TECHNICAL MANUAL
FIELD CHANGE BULLETIN

**REDUCE INTERNALLY GENERATED
INTERFERRING SIGNALS**

R390A/URR

REDUCTION OF INTERNAL INTERFERENCE

Figure 1(a)

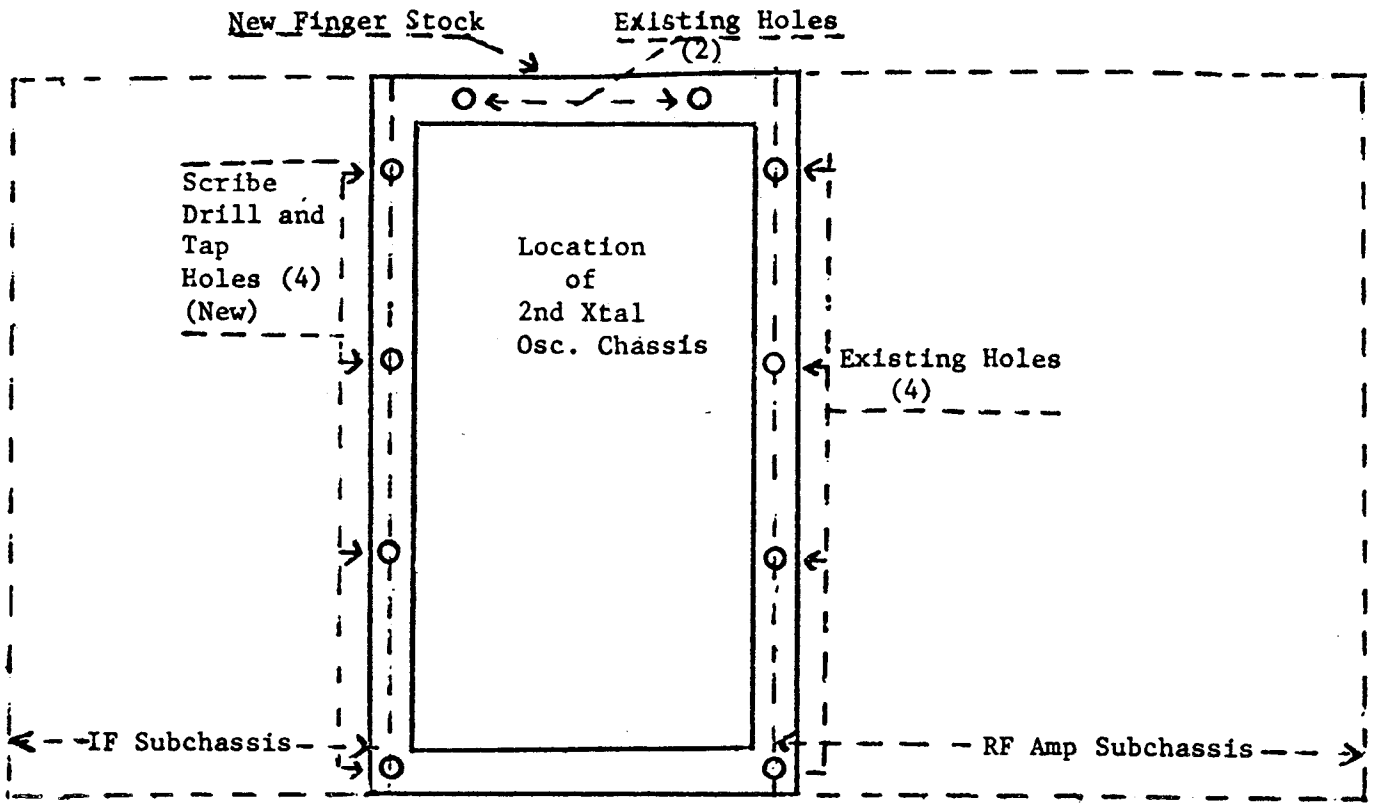
- CAUTION: DO NOT TURN SHAFT.
6. Remove the finger contact strip and mounting hardware presently mounted on the receiver main frame.
 - B. 1. Place the new finger stock, item 1(a), supplied with the kit, on the main frame of the receiver as shown in Fig. 1(a) of field change. Place so that the fingers are facing upward.

2. Using the four existing tapped holes and hardware which was previously removed, tighten the screws to hold the new finger stock in position.
 3. Using the new finger stock as a template, scribe the four holes on the left side of the receiver main frame as shown in Fig. 1(a). Remove the new finger stock and center punch the four holes which has been scribed.

Figure 1(b)

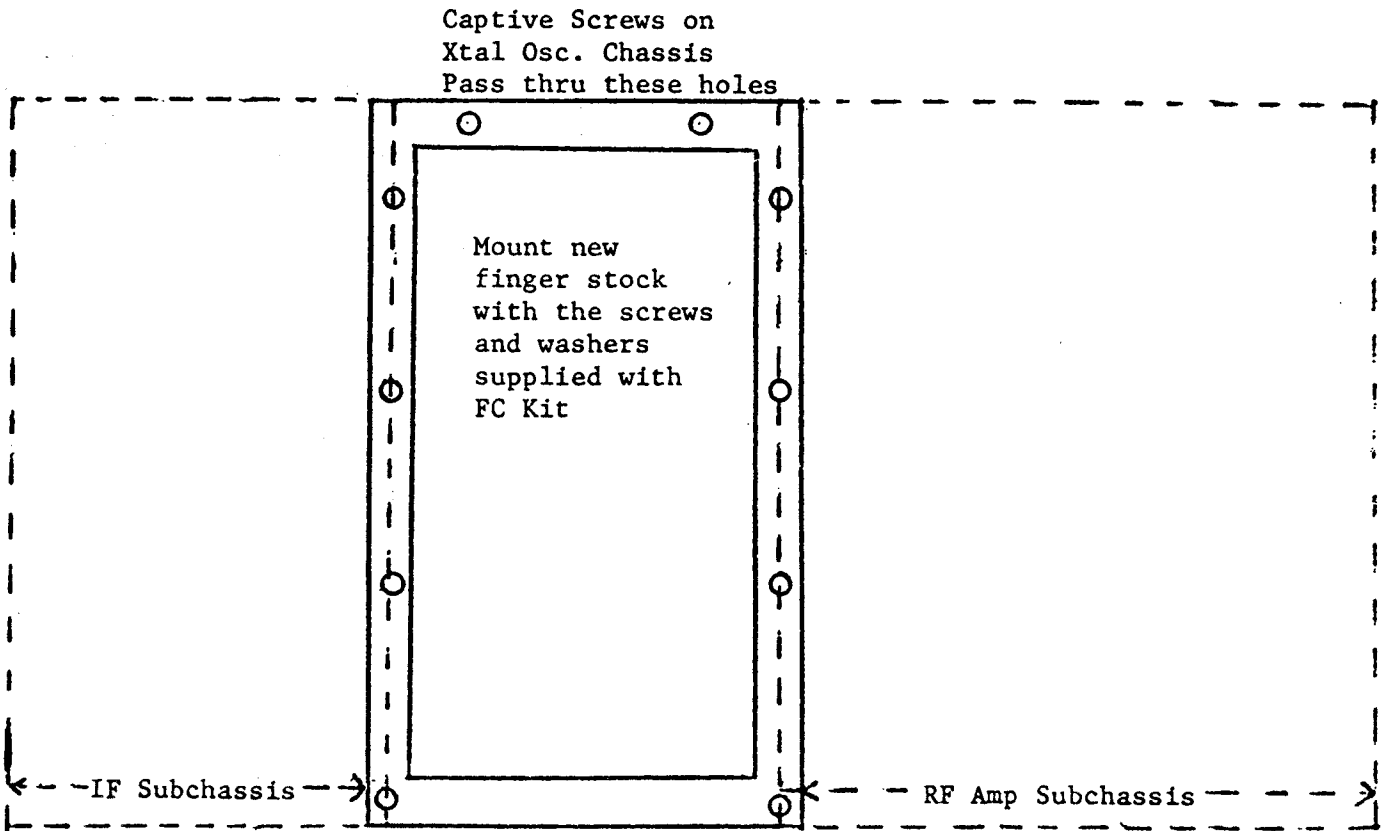
4. Using a #35 drill, drill the four holes and then tap with the 6/32 tap.
 5. Install the new finger stock, using the hardware, items 1(b), 1(c), and 1(d), supplied with the kit as shown in Fig. 1(b). Insure that the fingers are in the upward position.
